Re: **COMBINED STORMWATER MANAGEMENT  
CONCEPT/SITE DEVELOPMENT  
STORMWATER MANAGEMENT PLAN** for  
Kaiser Permanente Aspen Hill  
Preliminary Plan #: 120200130 Site:82018007A  
SM File #: 285660  
Tract Size/Zone: 10.03 Acres  
Total Concept Area: 10.64 Acres  
Lots/Block: TBD  
Parcel(s): N544, P534 (1-B)  
Watershed: Middle Rock Creek

SUBJECT: Final Forest Conservation Plan  
Property Name: Kaiser Permanente Aspen Hill  
Plan Number: SC2020011  
Tract area: 11.17 acres  
Land Use Category: Commercial

RE: Preliminary Plan No. 120200130  
Kaiser Permanente Aspen Hill

Thank you for the opportunity to review the traffic impact study (TIS) and traffic signal warrant analysis (TSWA) for the proposed **Kaiser Aspen Hill – 20APMO004XX** on **MD-185 Connecticut Ave** (Mile Point **8.02**) in **Montgomery** County. The Maryland Department of Transportation State Highway Administration (MDOT SHA) has reviewed the TIS and we are pleased to respond.

FIRE  
ACCESS  
PLAN

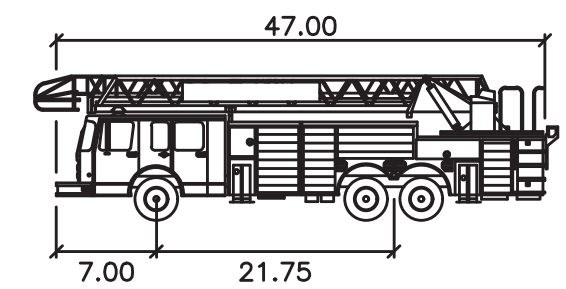
Review based only upon information provided in this plan. Does not cover unsatisfactory conditions resulting from omissions, errors, or omissions. Clearly indicate conditions on site. If such unsatisfactory layout or conditions will be required if found after installation.

**PLAN APPROVED**
